Well Name: CANDADO

Well Number: 13

Type of Submission: Notice of Intent

Type of Action Plug and Abandonment

EPIC Energy, LLC

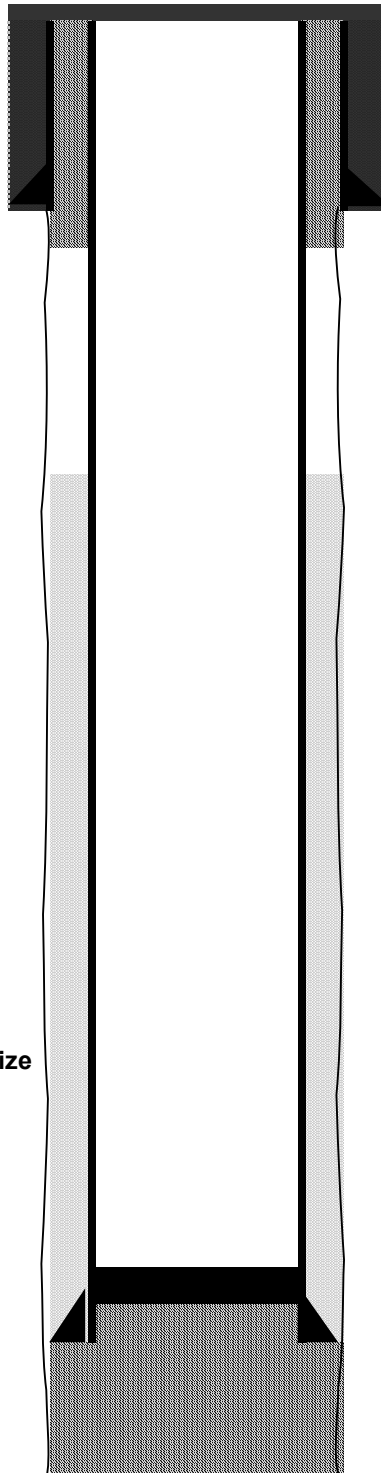
3. The following modifications to your plugging program are to be made:
 - a) Bring the top of Plug #3 (or an additional plug) up to 1966 ft. to cover the Ojo Alamo top. BLM picks top of Ojo Alamo at 2066 ft.

- b) Add an additional plug to cover a minimum of 50 ft. below and above the top of the Nacimiento formation at 685 ft. This may be an inside/ outside plug or balance plug depending on the CBL results.

- c) Bring the bottom of the surface plug down to 300 ft. Perforate also at 300 ft. to circulate cement to surface. If CBL shows top of cement above 300 ft., then perforate at the deepest location to ensure cement on the backside does circulate to surface.

- BLM formation top estimates for the Nacimiento and Ojo Alamo formation vary from Operator submissions.
- TOC was calculated by operator @ 1769'; a CBL is included as part of the P&A proposal.
- Bring the top of Plug #3 up to 1966', or pump an additional plug, to cover BLM estimate for the Ojo Alamo top @ 2066'.
- Add an inside/outside plug or balanced plug (depending on CBL results) to cover the BLM estimate for the Nacimiento formation top @ 685'.
- Recommend bringing Surface plug bottom down to 300'.
- Log analysis of reference well #2 indicates the Nacimiento and Ojo Alamo sands investigated likely contain fresh water ($\leq 5,000$ ppm TDS). By adjusting the plugs as described above, freshwater sands in this well bore will be protected.
- Pictured Cliffs open hole interval from 2858' - 2938'.
